RE: Objection of the West Virginia Highlands Conservancy to the proposed Greenbrier Southeast project, Monongahela National Forest, Greenbrier Ranger District (Jack Tribble, District Ranger and Responsible Official)

Objection to Greenbrier Southeast Project: Figures

Figure 1- Historic and current distribution of the candy darter in relation to the Monongahela National Forest in West Virginia and the George Washington-Jefferson National Forest in Virginia.

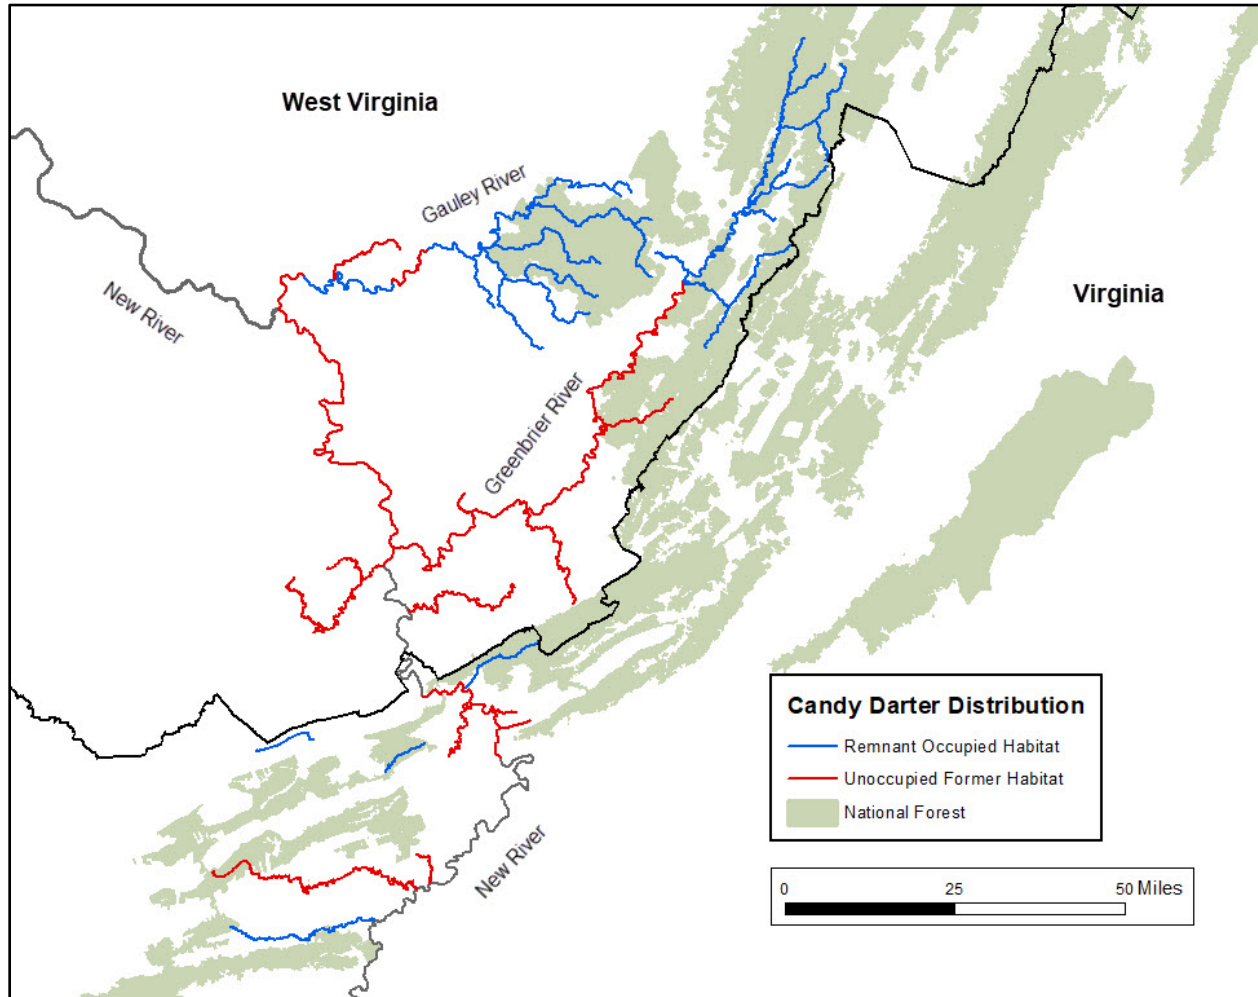
At this point, the candy darter is dependent on Forest Service management of watershed areas that determine the condition of the remaining occupied candy darter habitat. As indicated in **Figure 1**, much of the designated critical habitat for the candy darter, which includes most of the occupied habitat, is in the National Forests, the MNF and the George Washington-Jefferson National Forest (GWJNF).[5] The MNF includes the most extensive and connected of the streams that comprise this habitat.

Figure 2 – Location of Aquatic Ecosystem Unit Inventory sites in the Greenbrier Southeast project area.

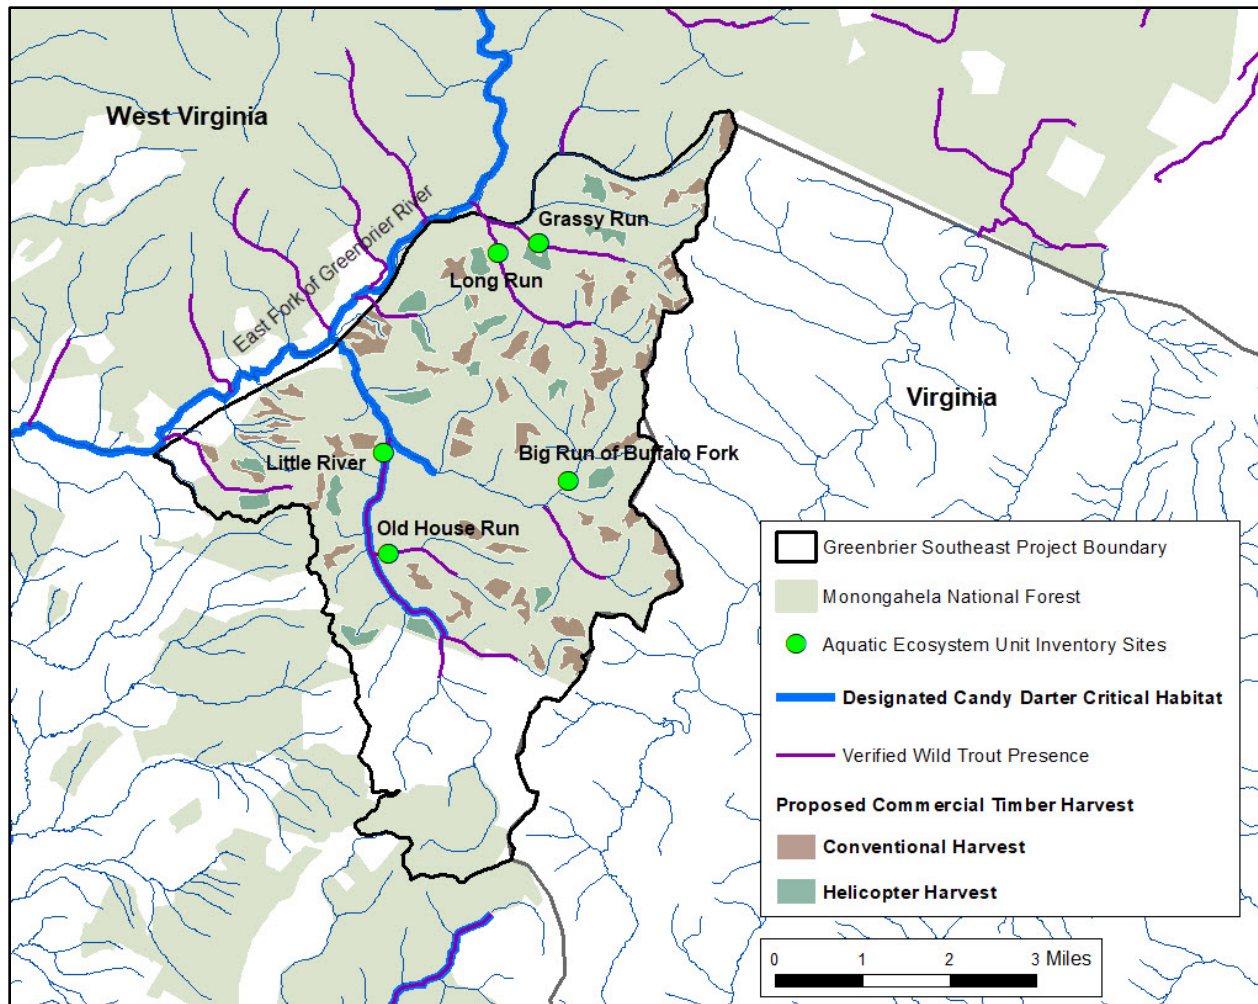
The sedimentation data available for the GSE project area was collected at five locations (**Figure 2**). Between 2008 and 2018, percent fine sediment (both < 1 mm and < 4 mm particle size) in spawning gravel was determined three times for one location and two times for four locations. **Figure 3** shows the percent fine sediment values for the five locations in relation to detrimental effects criteria applied in the 2021 monitoring and evaluation report.

Figure 3 - Percent fine sediment values for Aquatic Ecosystem Unit Inventory (AEUI) program sites in the Greenbrier Southeast project area – shown in relation to detrimental effects criteria for coldwater fish.

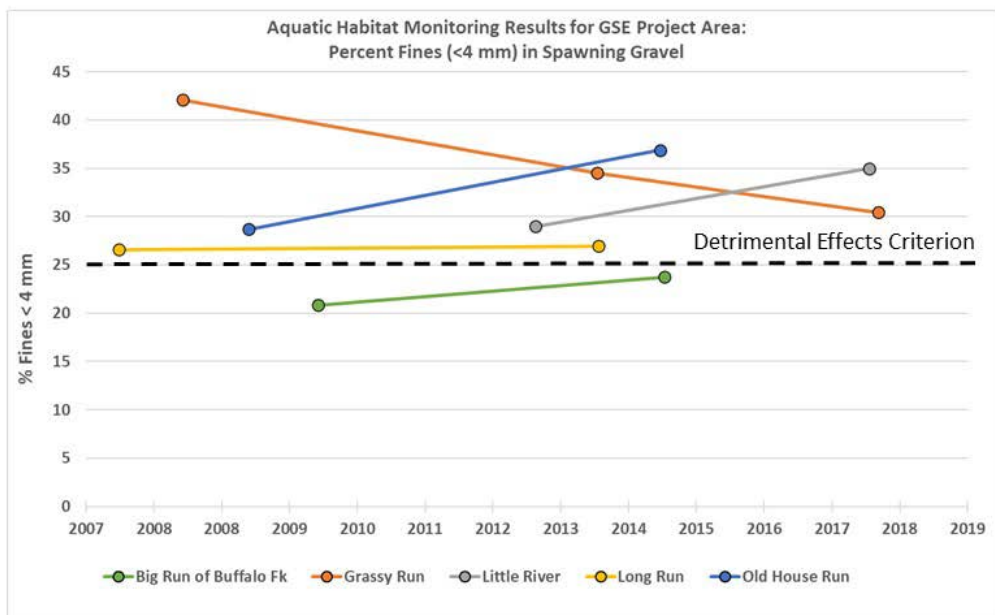
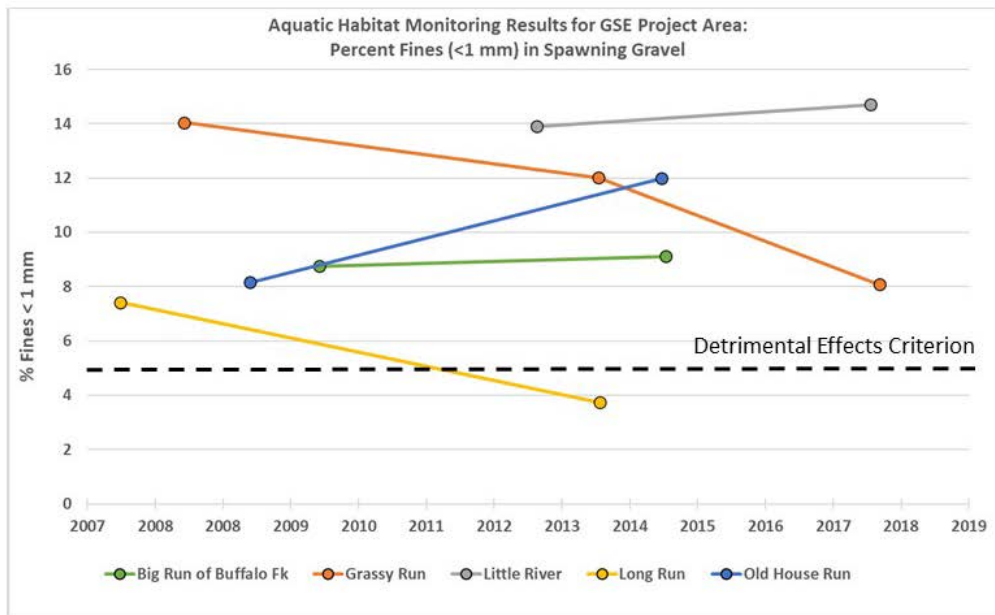
Percent fine sediment exceeded the criteria for detrimental effects to native coldwater fisheries at all the data collection locations, and percent fine sediment increased between the earlier and later data collection at most of the data collection locations.

Consistent with observations for streams throughout the MNF, the streams in the GSE project area, including streams designated as critical habitat for the candy darter and streams that drain directly to critical habitat for the candy darter, are degraded by chronic sedimentation, which is mostly getting worse.

This is not correct for three of the five fine-sediment data collection locations in the GSE project area.

Figure 4 - Monongahela National Forest management projects including designated critical habitat for the candy darter.

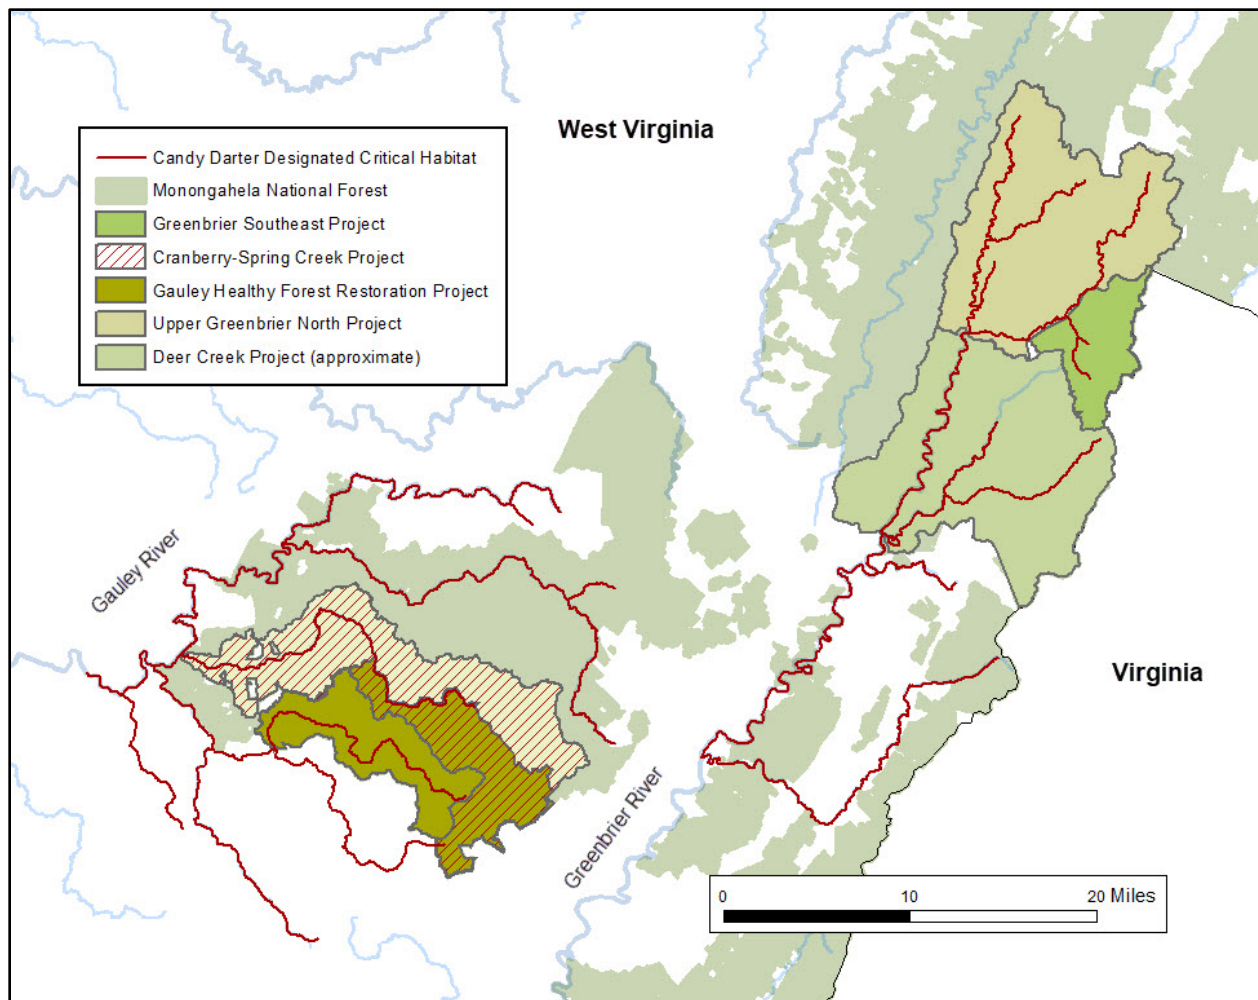
Figure 4 shows the locations of MNF projects in the pre implementation or implementation phase that may affect designated critical habitat for the candy darter. While these projects differ with respect to project review and ecological sensitivities, they share a common failure to address the issue of existing sedimentation impacts to candy darter habitat. Thus far, the review process for these projects has failed to include an analysis of existing sedimentation impact, has failed to determine what level of additional sedimentation would be significant, and has failed to provide any estimate of potential additional increments of sedimentation that may result due to the projects. These projects instead rely on project design and mitigation measures that, as described above, are unreliable for prevention of sediment production and delivery to streams.
